44473A-01A

S E R V I C E N O T E

Defective connectors shipped with 44470A, 44471A, 44473A, 44474A

Figure 3: Defective Connector with all pins on one side

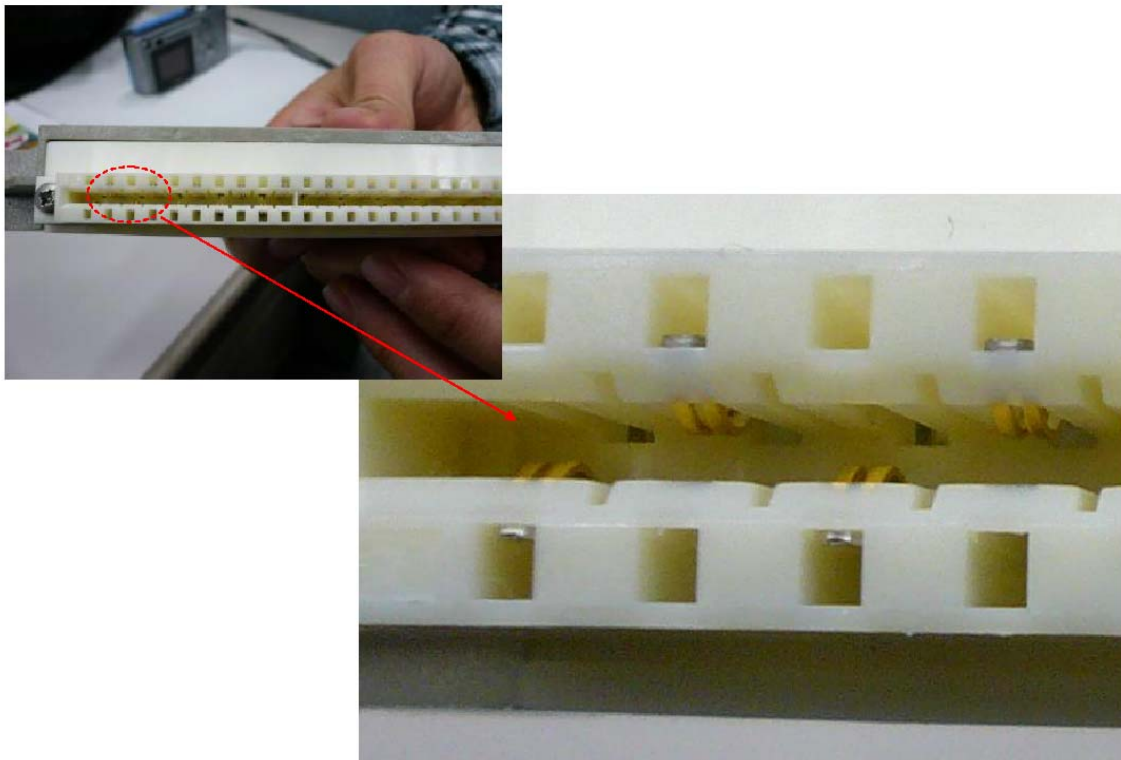
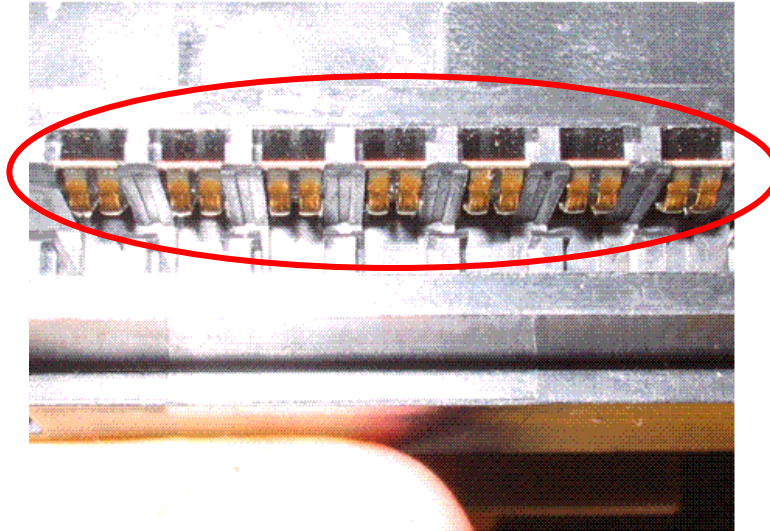
The 44470A, 44471A, 44473A, and 44474A contain a main relay card and a removable screw terminal block (see Figure 1). Some of the removable terminal blocks that were shipped between 1-Jan-2008 and 08-April-2008 have a defective connector that results in half of the pins being unconnected.

The 44470A, 44471A, 44473A, and 44474A products consist of a main relay plug in module and a removable terminal block (see Figure 1). These are plug in modules for the card cage mainframes 3488A, 3499A, 3499B, and 3499C. The main relay card contains the serial number. The removable terminal module does not contain a serial number. It is possible that over time a terminal block will no longer be used with the same serialized relay card that it was shipped with. A visual inspection of the connector in the removable terminal block is necessary to determine if a defective connector is present. The visual inspection should override the serial number range limits. All white colored connectors are good and have pins that alternate top to bottom (see Figure 2). A black colored connector is bad if it contains all pins on one side of the connector (see Figure 3). A black colored connector is good if it contain pins that alternate top to bottom (not pictured).

The procedure to correct the defective connectors is very simple. One must replace the defective connector with a good connector (see connector part numbers list on page 2). The customer may perform this procedure or have an Agilent-qualified person perform this procedure.

Figure 4: Removing defective connector from terminal block

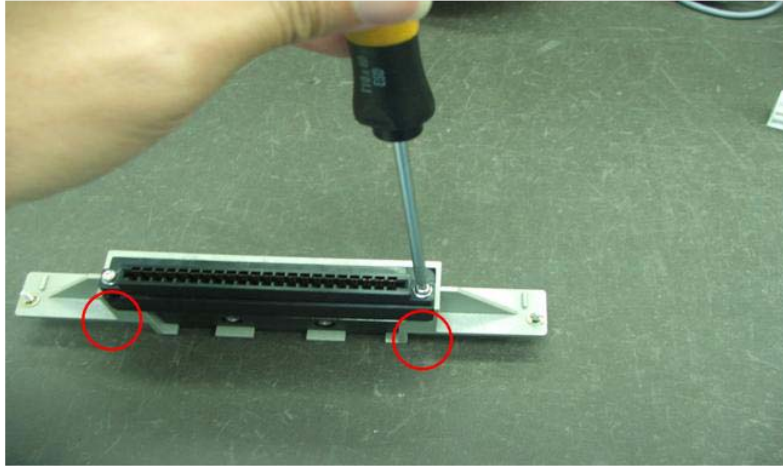
Connector Replacement Procedure: After identifying a defective connector, the connector in the terminal block is repaired by removing the two screws that hold the connector to its case. Note the orientation of the connector. This will release the connector from the terminal block and then a good one can replace it. No soldering is necessary. See Figure 4.

1. Use a T10 torx driver to unscrew the 2 screws of the connector.

Use the same torx driver to screw on the good connector, using the same orientation at the connector you just removed (see Figure 5).
